NSL Initial Application

NSL-7906

Re: Application of Chevron U.S.A. Inc., for administrative approval of an unorthodox well location for its CB SE 5 32 Fed Com 003 No. 3H Well in the W/2 of Section 32, Township 23 South, Range 29 East, and the W/2 of Section 5, Township 24 South, Range 29 East, N.M.P.M., Eddy County, New Mexico.

WELL LOCATION AND ACREAGE DEDICATION PLAT

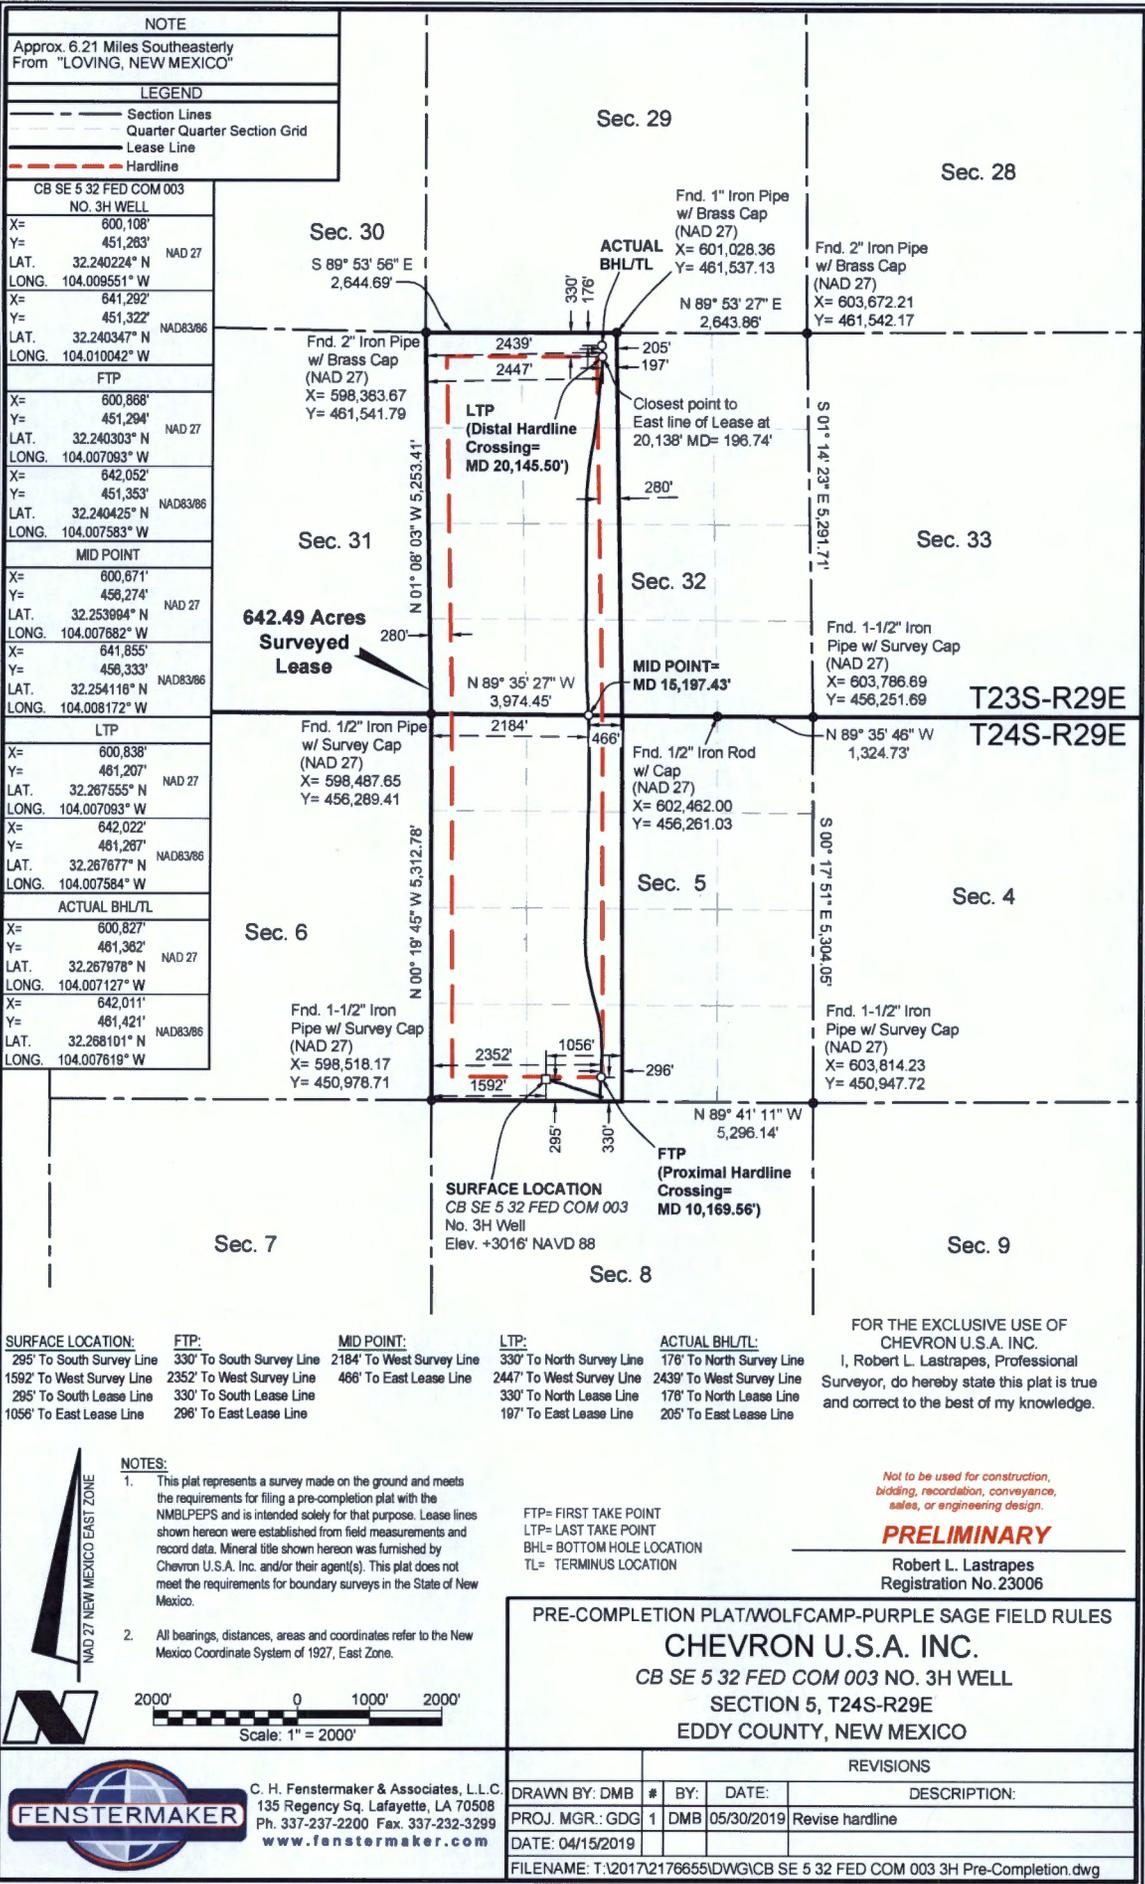
There appears to be some discrepancies within the application you have provided. None of your references to your FTP and LTP information are consistent.

FTP = 330 FSL & 2352 FWL
LTP = 1117 FNL & 2365 FWL

Your C-102 stating

FTP = 330 FSL & 2178 FWL

LTP = 330 FNL & 2178 FWL

Exhibit B stating

FTP = 330 FSL & 2352 FWL

LTP = 330 FNL & 2447 FWL

What are the correct FTP and LTP you wish to use for this Unorthodox Location request? Remember, you are requesting an Exception to the rule. In order to grant an exception, all pertinent information must be concise, correct, and informative within your request.

Chevron requests the following NSL location:

SHL: 295' FSL & 1,592' FWL
BHL: 176' FNL & 2,439' FWL
FTP: 330' FSL & 2,352' FWL
LTP: 330' FNL & 2,447' FWL

These locations correspond with **Exhibit B** (plat). Chevron also indicates on Exhibit B the location in which the completed interval will not comply with the 330' setback requirements of the Special Rules for the Purple Sage Wolfcamp, which necessitates this NSL request. Please let me know if you require any further clarification to process this application administratively.
